1. **Site Address:** Crowndale House, Crowndale Road, Camden, London, NW1 1TP
2. **Project:** Cladding remediation to existing 6 storey block of flats
3. **Inspection Date:** 17/01/2025
4. **Weather:** Overcast
5. **Inspection Number:** 01
6. **Site Contact:** Ben Lockerby (GPF Lewis) – 07840 838 438
7. **Inspection Type:** External Wall Survey

8. Overview

9. Summary

SOUTH ELEVATION

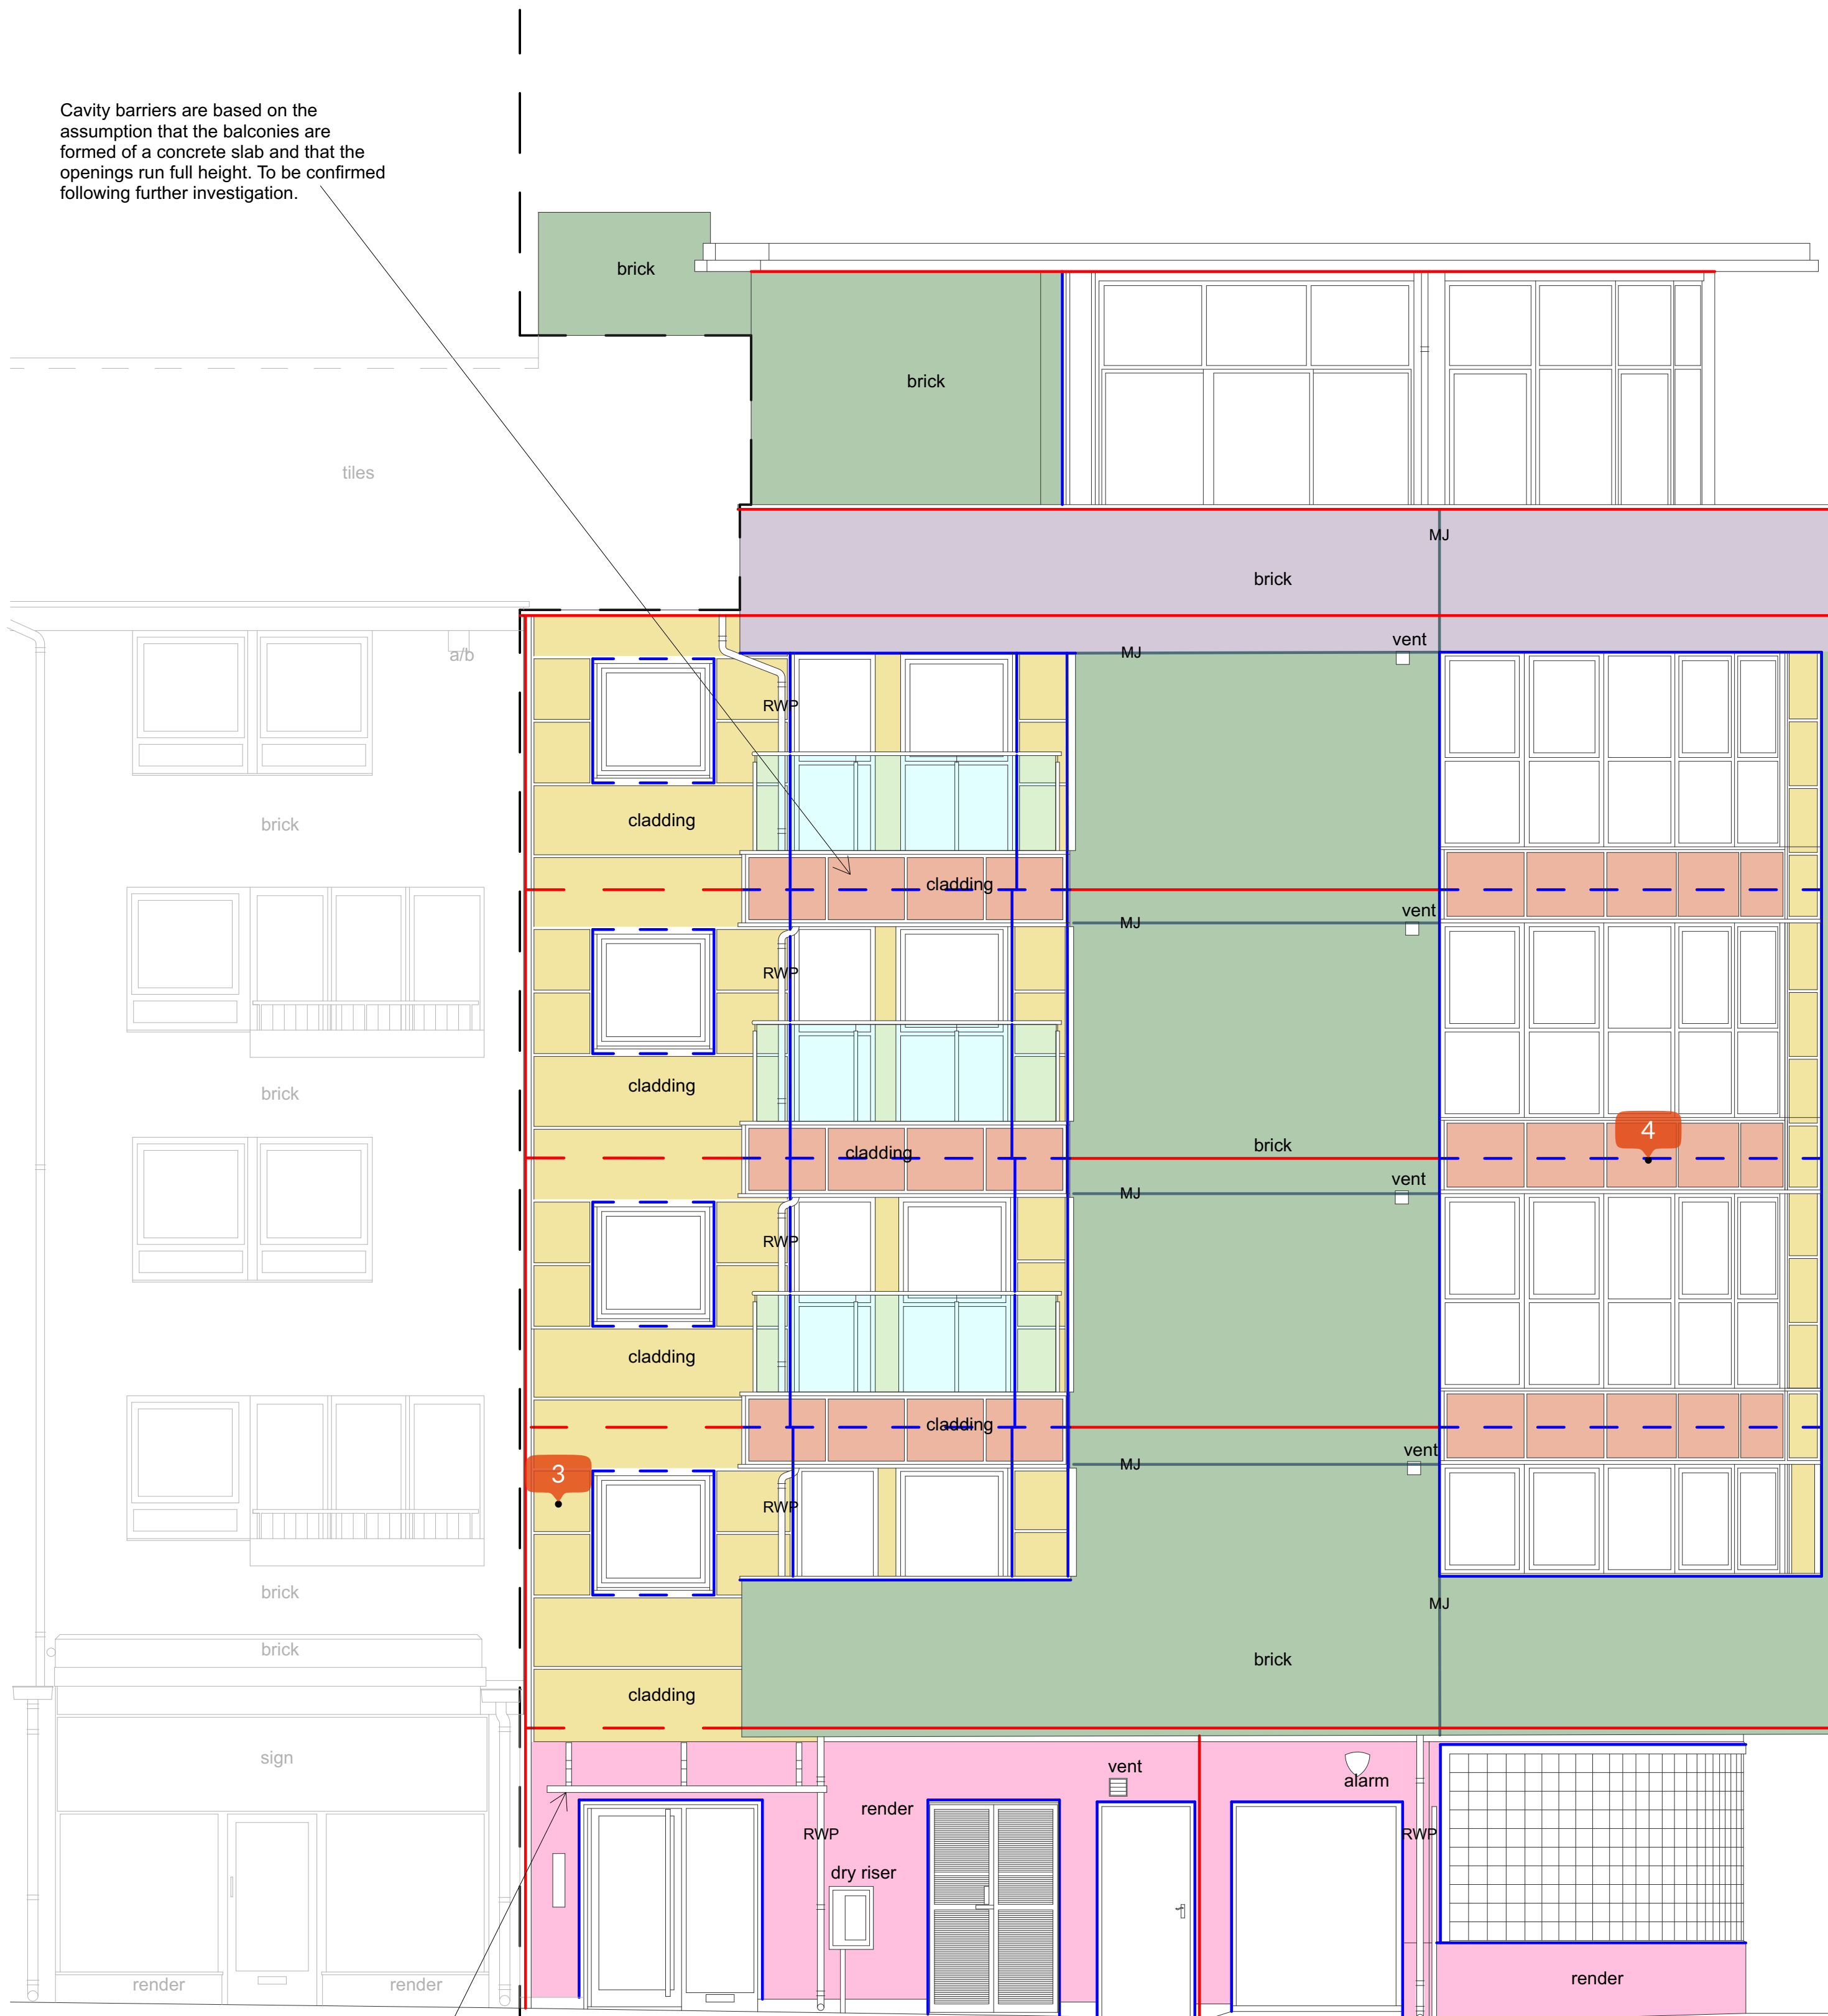
Cavity barriers are based on the assumption that the balconies are formed of a concrete slab and that the openings run full height. To be confirmed following further investigation.

canopy to be removed and refixed, extended fixing brackets may be required. Render will be thicker than the timber panel

WEST ELEVATION

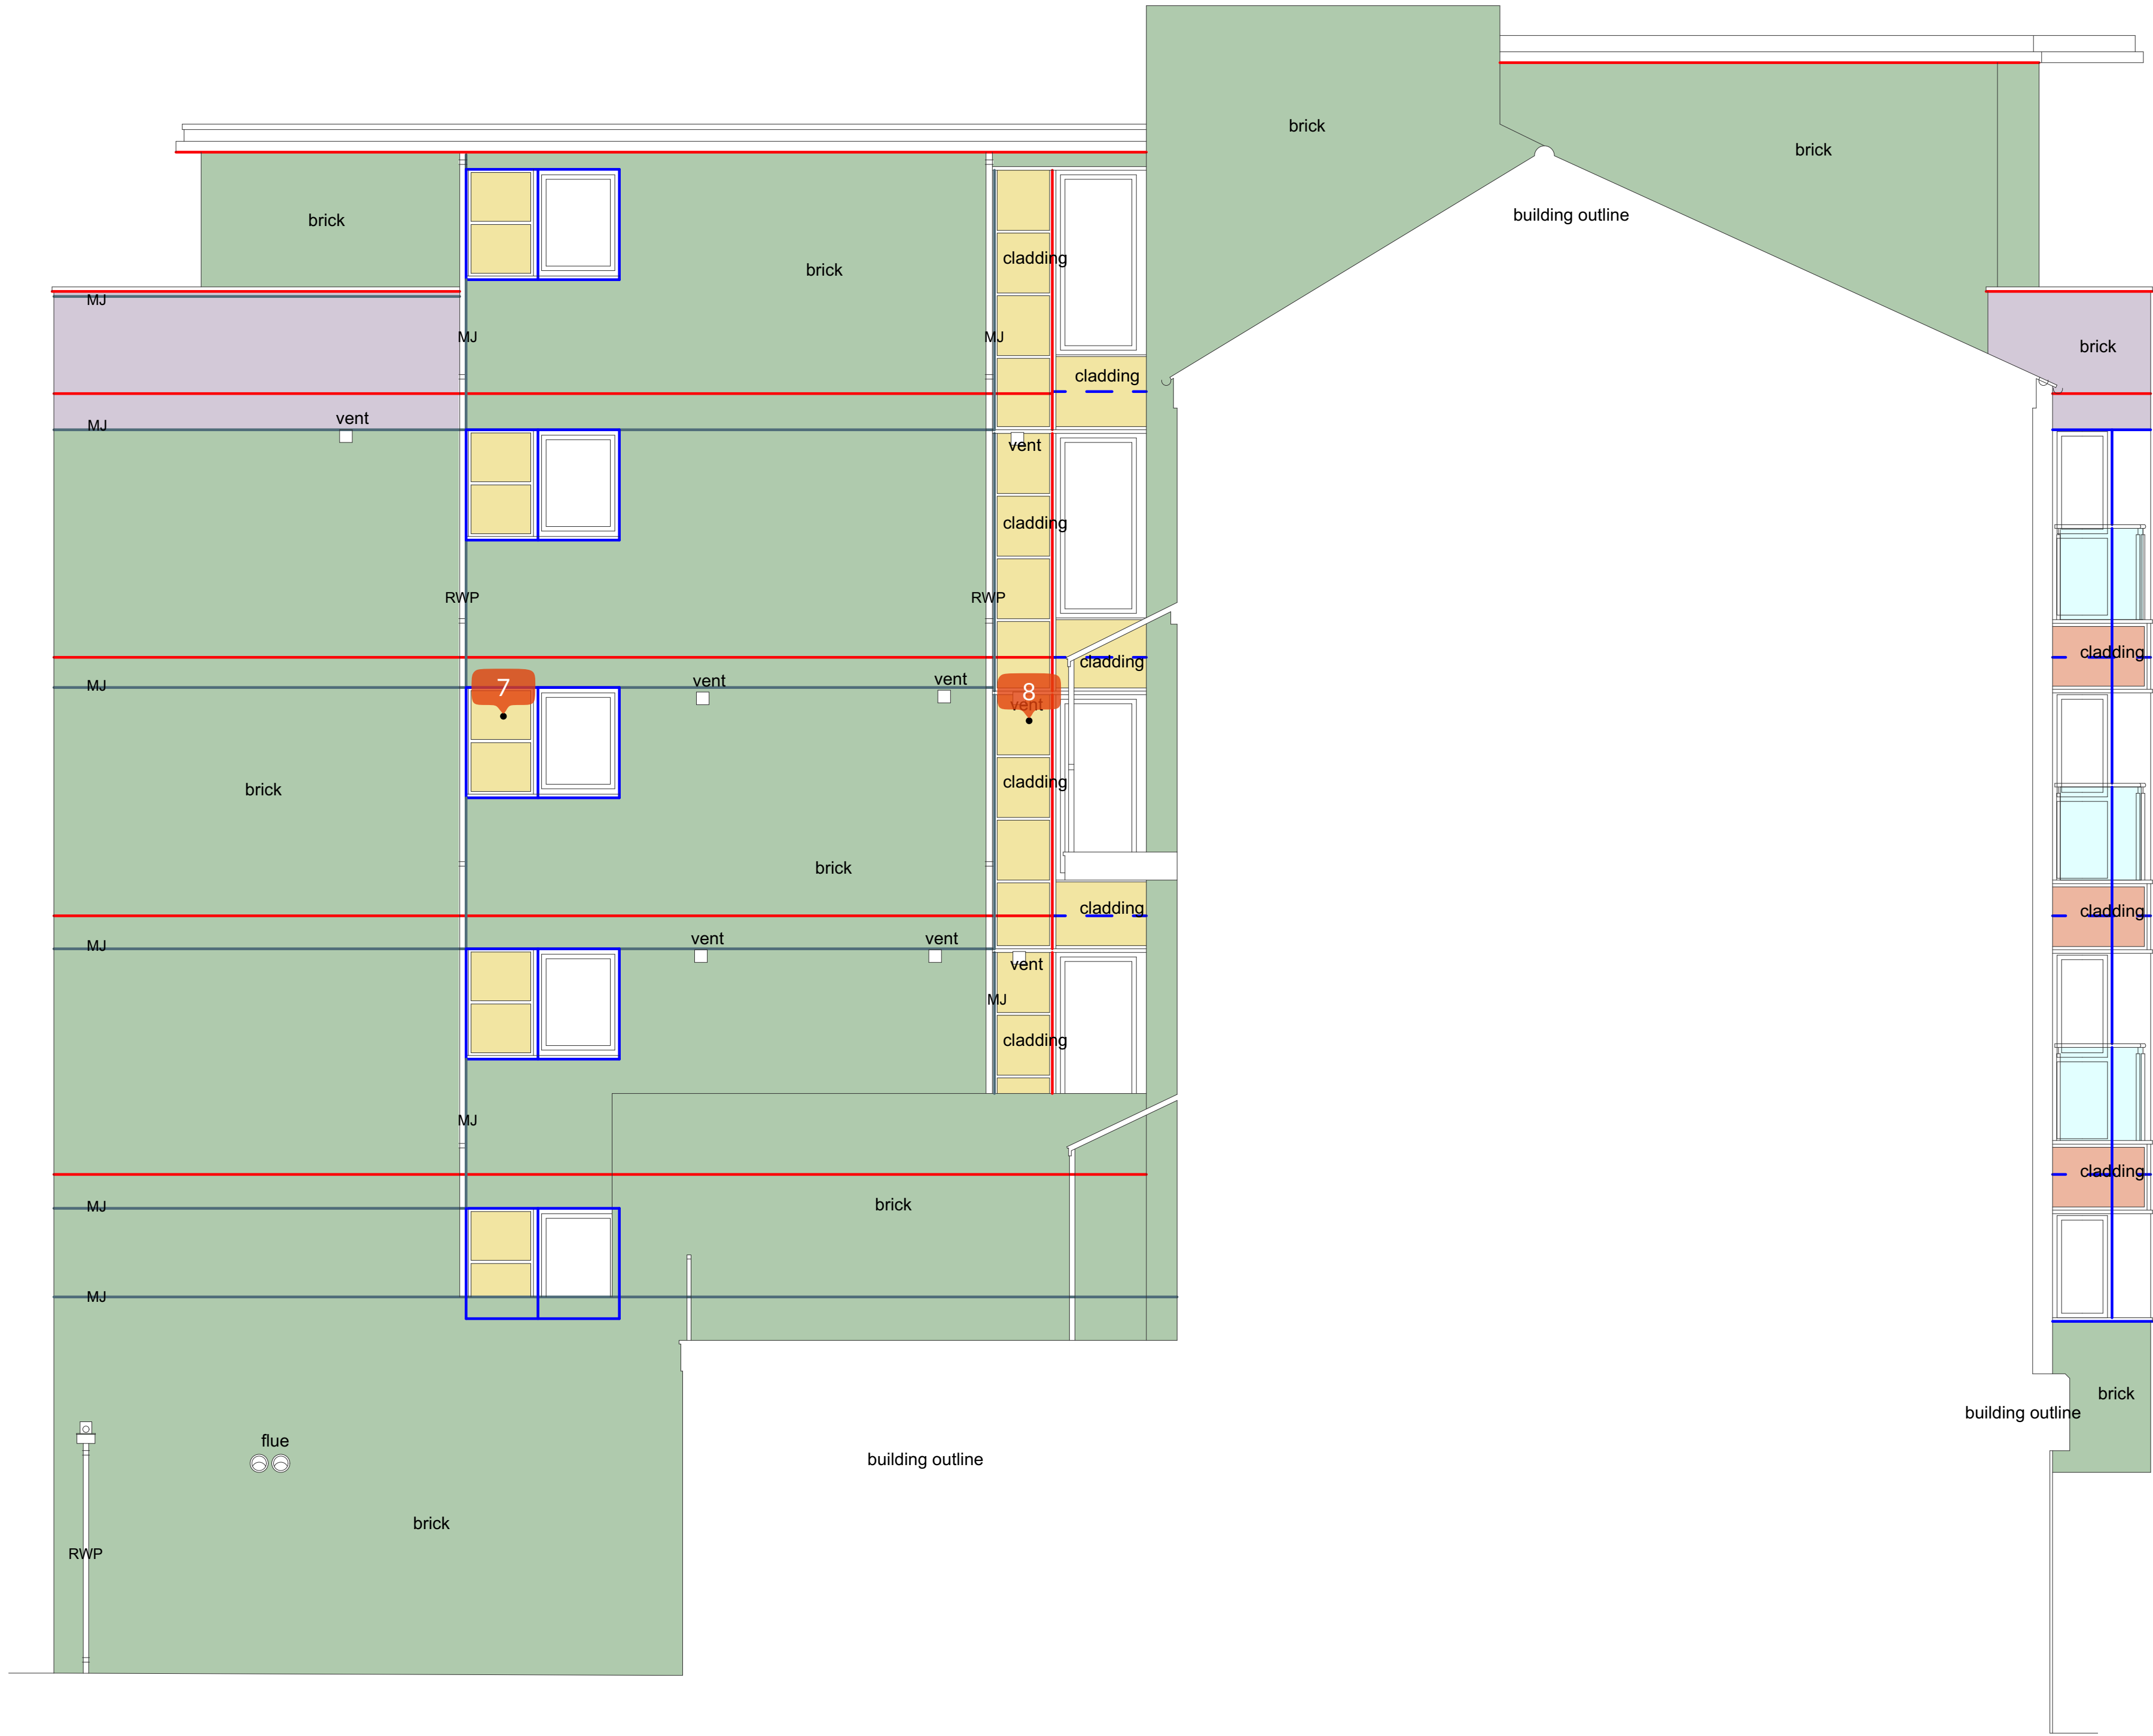
PLEASE NOTE:
THESE ARE **NOT** AS BUILT DRAWINGS. ALL
DISCREPANCIES ARE DUE TO "AS BUILT" INFORMATION
AVAILABLE - NEEDS FURTHER CONFIRMATION
